THIRD AMENDMENT TO MASTER DEED  
MEADOW VIEW ESTATES

This Third Amendment to the Master Deed of Meadow View Estates is made and executed this 13<sup>th</sup> day of September, 2002, by Berhart Land Co., LLC, a Michigan limited liability company (the "Developer") whose address is 399 Old U.S. 23, Brighton, Michigan 48114. The Developer has established MEADOW VIEW ESTATES, as a condominium project pursuant to the Master Deed thereof as recorded on August 10, 2000 in Liber 2810, Pages 805 through 826, inclusive, as amended by First Amendment to Master Deed, recorded in Liber 3254, Pages 762 through 805, inclusive, as amended by Second Amendment to Master Deed, recorded in Liber 3254, Pages 806 through 810, inclusive, Livingston County Records and designated as Livingston County Condominium Subdivision Plan No. 197 and the Developer does hereby execute and declare this Third Amendment to the Master Deed of Meadow View Estates pursuant to the authority granted in Article VI and Article VIII-2a of the Master Deed for the purposes of expanding the Condominium from twenty-eight (28) Units to fifty-seven (57) Units by the addition of land as described in Section 1 below, redefining the com

HARNUZ L. LURKONCZ  
LAND SURVEYORS  
2183 PLESS DRIVE  
BRIGHTON, MICHIGAN 48114  
(410) 227-9333  
PROPOSED DATED  
SEPTEMBER 10, 2002  
SHEET 5A

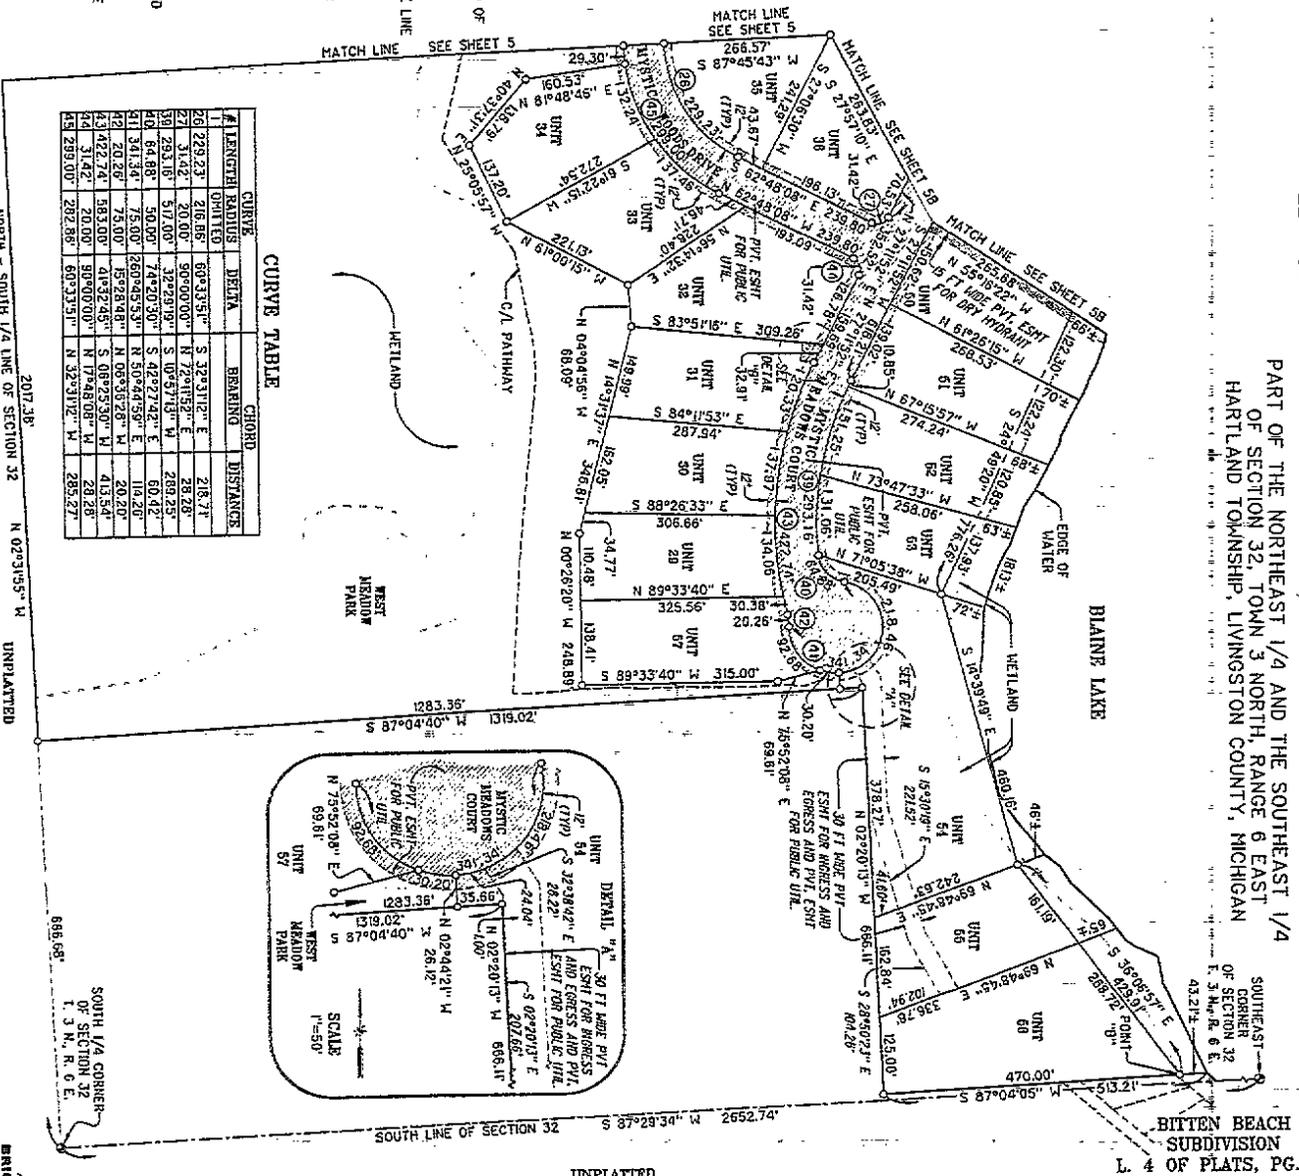
10. Sheets 5A, 5B, 8A and 8B of Replat No. 1 of the Condominium Subdivision Plan of Meadow View Estates, as attached hereto, shall, upon recordation in the office of the Livingston County Register of Deeds of this Amendment, be incorporated as part of the Condominium Subdivision Plan of Meadow View Estates.

DESIGNED BY: *Harjusz Lukonicz*  
 HARJUSZ L. LUKONICZ  
 PROFESSIONAL SURVEYOR No. 38119  
 SEPTEMBER 10, 2002  
 PROPOSED DATED  
 SHEET 6

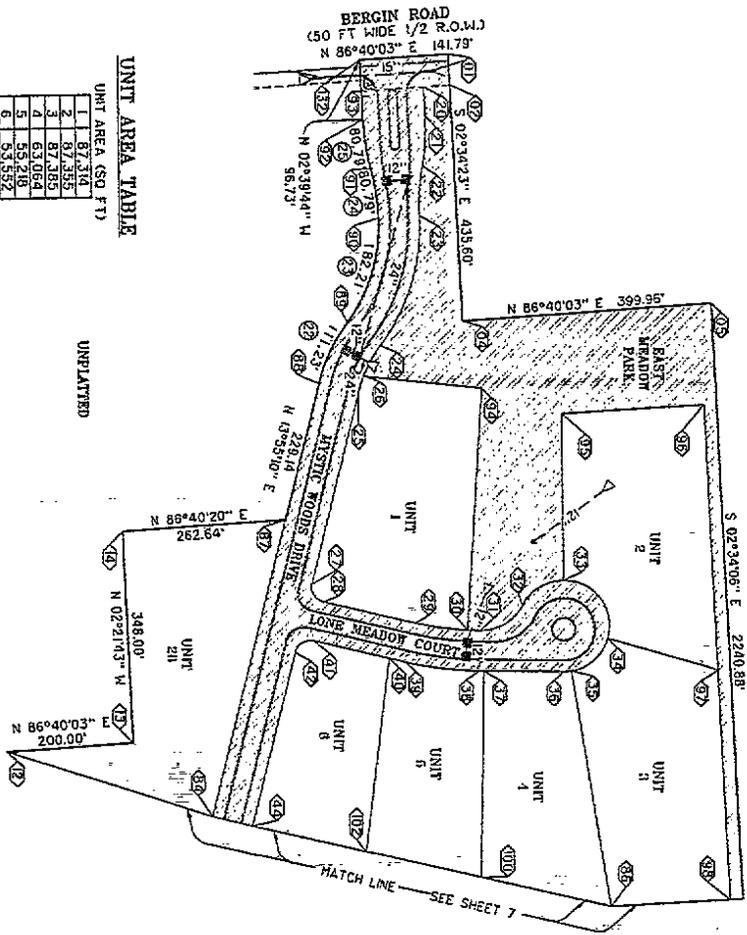
9. Sheets 1, 2, 3 and 6 of Replat No. 1 of the Condominium Subdivision Plan of Meadow View Estates, as attached hereto, shall, upon recordation in the office of the Livingston County Register of Deeds of this Amendment, replace and supersede originally recorded Sheets 1, 2, 3 and 6 of the Condominium Subdivision Plan of Meadow View Estates, and the aforescribed originally recorded Sheets shall be of no further force or effect.
